**RE: LHM Jeep
Grading and Drainage Plan (Stamp Date 3-31-2016)
Hydrology File: K19D023**

RE: LHM Jeep Parking- K19D023
Comments March 04, 2016

Comments on 1-27-16 submittal:

From: Abiel X. Carrillo
To: ["arverdt@awaeng.com"](mailto:arverdt@awaeng.com)
Cc: [Cherne, Curtis](#); [Harmon Rita T.](#)
Subject: RE: LHM Jeep - K19D023 - Stamp Date 3-31-2016
Date: Monday, April 11, 2016 5:11:00 PM

Grading and Drainage Plan

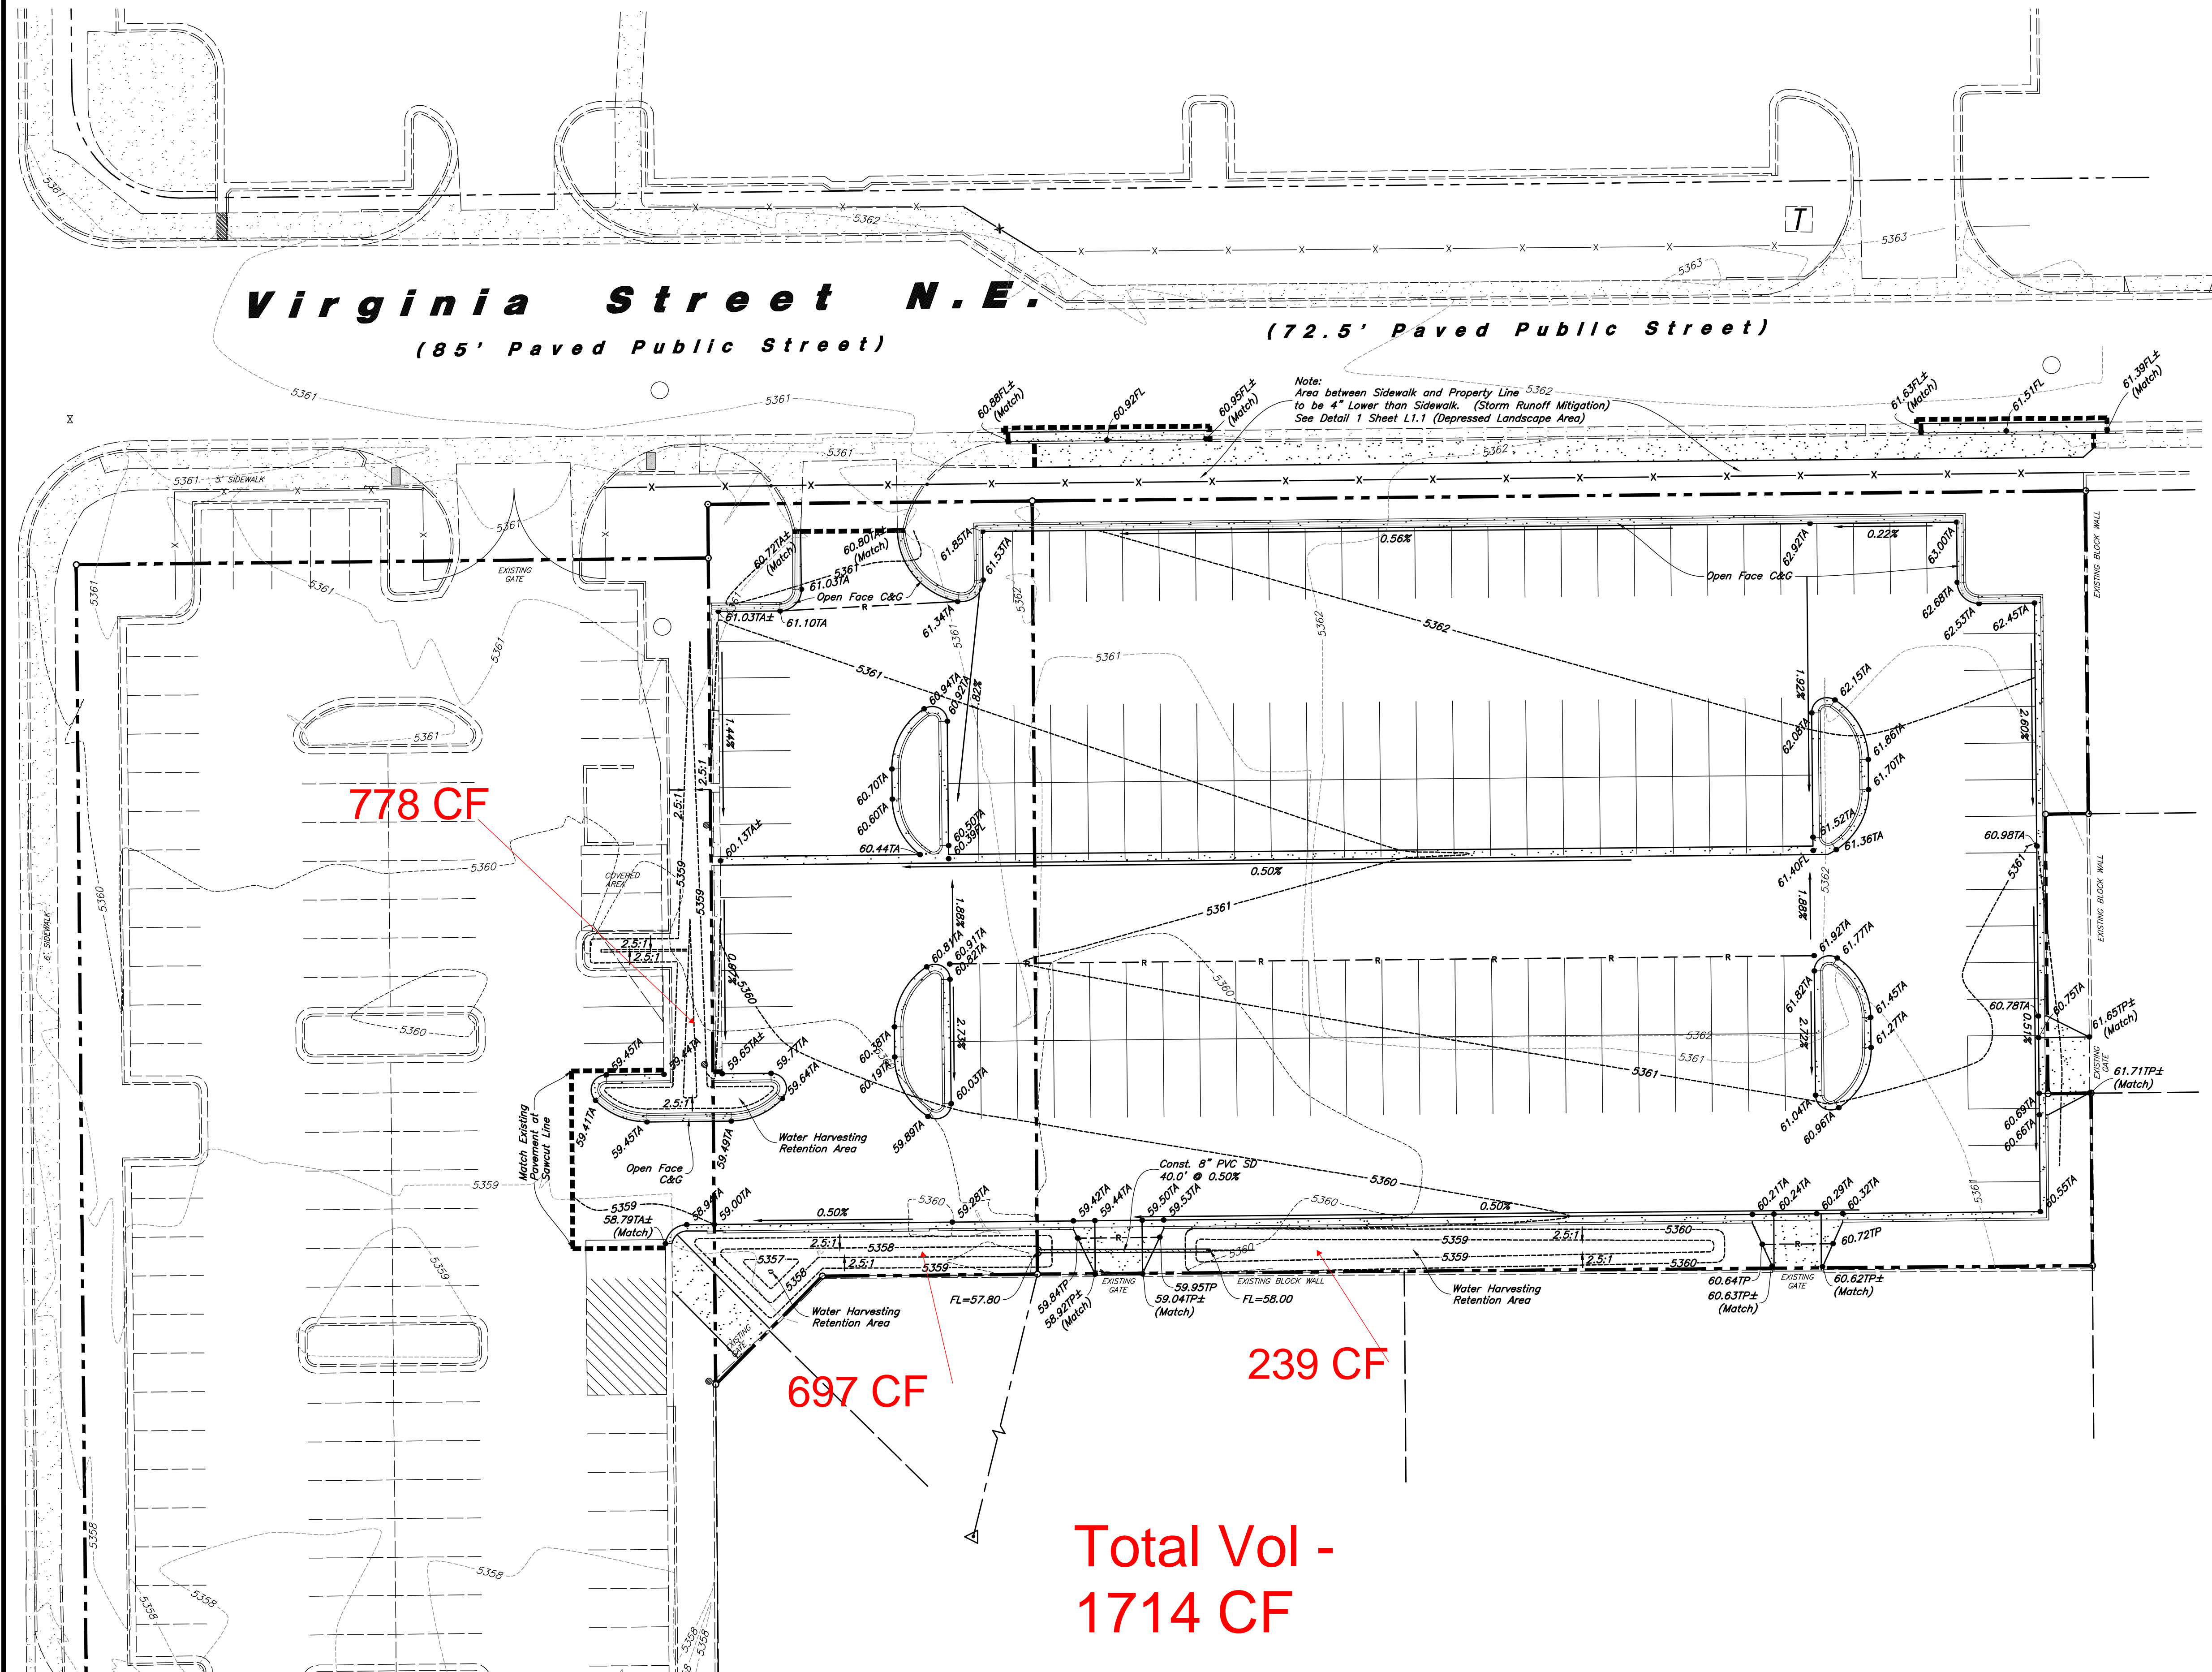
Comment: It appears that an underground storage and pre-treatment system is proposed to address the first flush volume. This solution is acceptable. However, the designer may consider using the new median islands and the long landscaped areas along the west side of the lot for water harvesting above ground, and if possible, eliminate the need for pre-treatment and underground system.

Comment: There is a low spot near the CDS unit (EL 59.18).

1. We agree with the concept of replacing the underground structure with surface management for first flush; it will be easier to manage and maintain. However, the total calculated required volume needs to be accounted for. I also left you a message regarding maximizing the volume provided. **Per your follow up exhibit, the pond volume provided exceeds the required volume. Item resolved**

- a. Provide a calculation on the plan of the total first flush volume provided, and call out the pond bottom of each ponding area (unless you provide a labeled contour).
Provided in the exhibit
2. Starting February 1, 2016, the Hydrology Department requires that the ESC Plan is approved prior to approval for Building, Grading, and Paving Permit. We recommend resubmitting once that approval has been secured. We did receive the ESC Plan, and it will be reviewed by the Stormwater Quality Engineer. Please contact him directly if you have any question: Curtis Cherne, 924-3420, ccherne@cabq.gov.
3. Call out the curb cut locations on the Grading Plan. They are shown on the site plan in the construction set.
4. For your information, evidence of the proposed lot consolidation will be required prior to approval for Certificate of Occupancy. Owner is working on the consolidation

Response: Water harvesting retention areas added along the west side of the lot and in the landscaped area north of the new improvements. The pre-treatment and underground system deleted.

Response: Low spot to remain and a curb opening added for runoff to enter the water harvesting retention area.
